## REMARKS

Appl. No. 09/521,588  
Appt. Dated 4/15/04  
Reply to Office Action Dated 1-15-04  
Annotated Sheet Showing Changes

FIG. 1

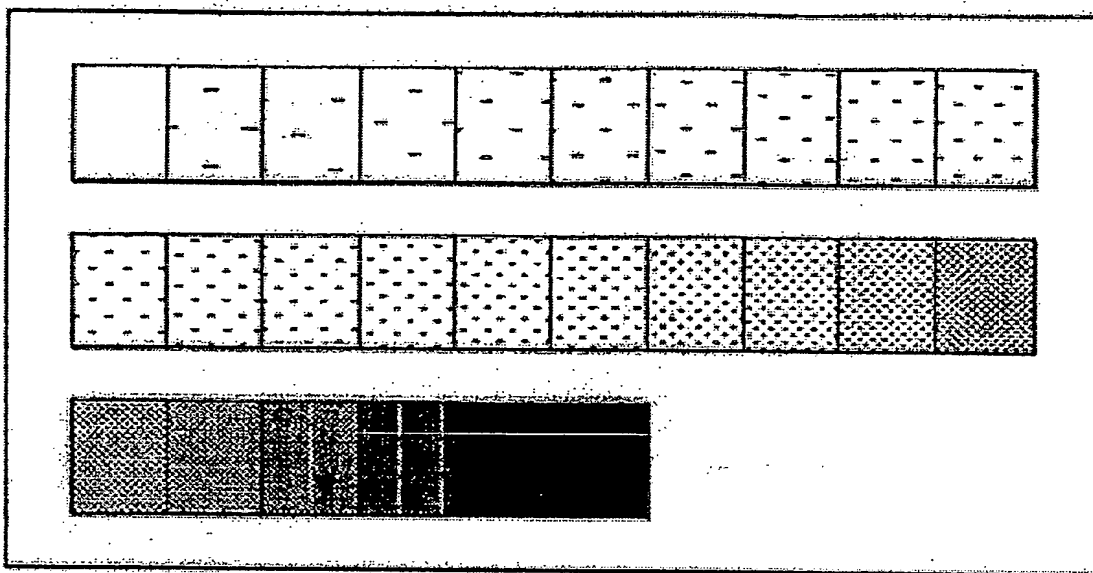
Regarding the drawings, Figure 1 has been amended to include the label PRIOR ART as required on page 4 of the application.

The amendments to Figures 1 and 2 are shown in red on the attached copies of the Figures.
